STAFF RECOMMENDATION
1305 Lillian Street
October 16, 2013

Application: New construction - infill
District: Lockeland Springs-East End Neighborhood Conservation Zoning Overlay
Council District: 06
Map and Parcel Number: 08313011201
Applicant: Jamie Pfeffer, Pfeffer Torode Architecture
Project Lead: Sean Alexander, sean.alexander@nashville.gov

1 FRONT ELEVATION
SCALE 1/8" = 1'-0"

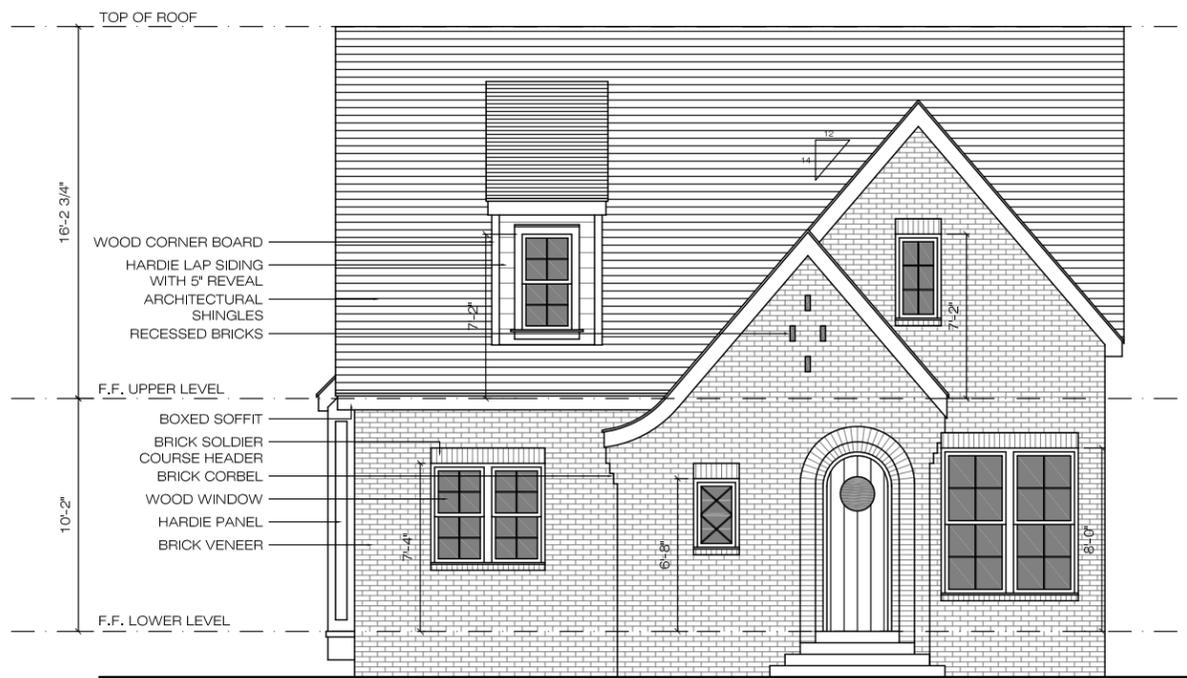
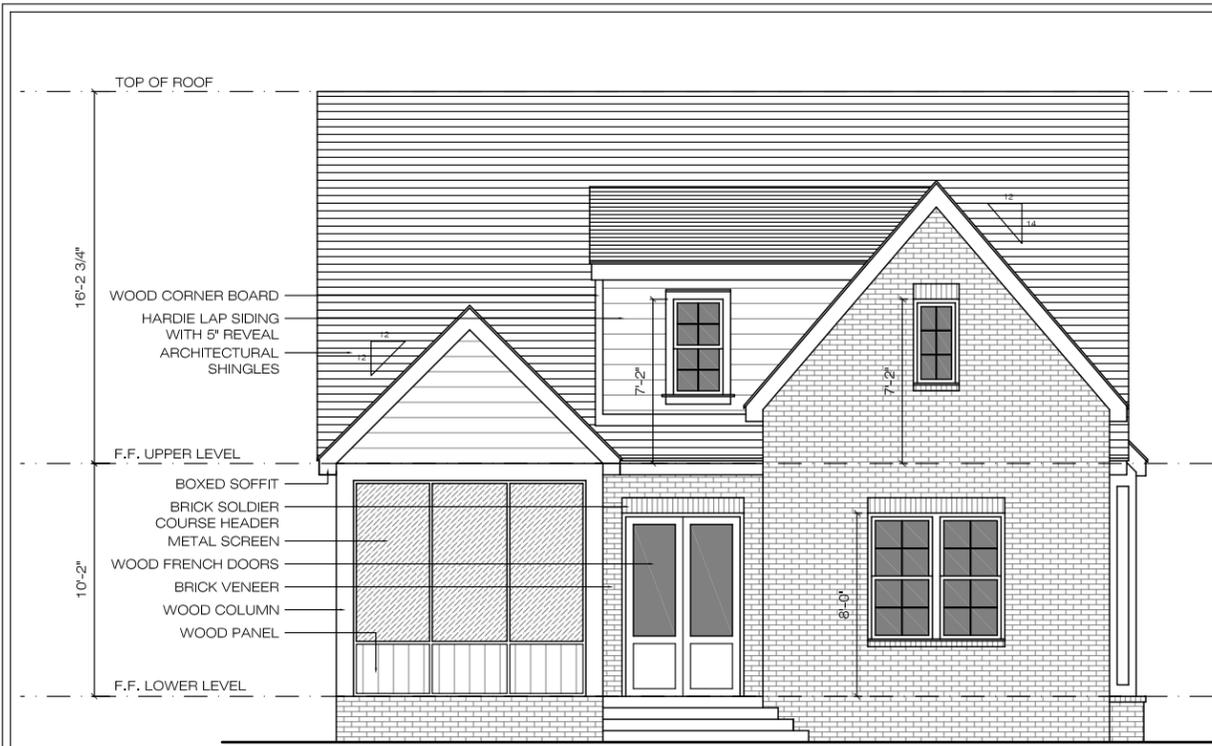
The new house will have a roof ridge height of twenty-six feet (26') above the finished floor level. The floor level is not evident on the exterior of the building, but would vary from two feet (2') at the rear to seven feet (7') at the front as grade drops toward the front of the lot. The recently constructed houses at 1209 and 1211 Lillian Street have similarly sloped lots, but only have approximately five feet (5') of exposed foundation at the front.

The house will have brick on the first story walls continuing down to grade, whereas it is typical of houses in the historic district to have a visible expression of the floor level on the exterior by using different materials for the foundation and primary walls. The height of the house from floor to roof peak is compatible with other houses on Lillian Street, but the perceived height with the foundation as viewed from the right of way would be exaggerated by the material and grade. A change of materials at the foundation level and re-grading or lowering the foundation height at the front of the house to match the recently constructed buildings at 1209 and 1211 Lillian Street would be more appropriate.

- The material of the foundation be changed in order to express the level of the finished first floor on the exterior of the building.
- That the foundation height and grade at the front match the recently constructed houses at 1209 and 1211 Lillian Street.
- Staff to have final approval of the brick, windows and doors, and the material of the stairs and walkways.
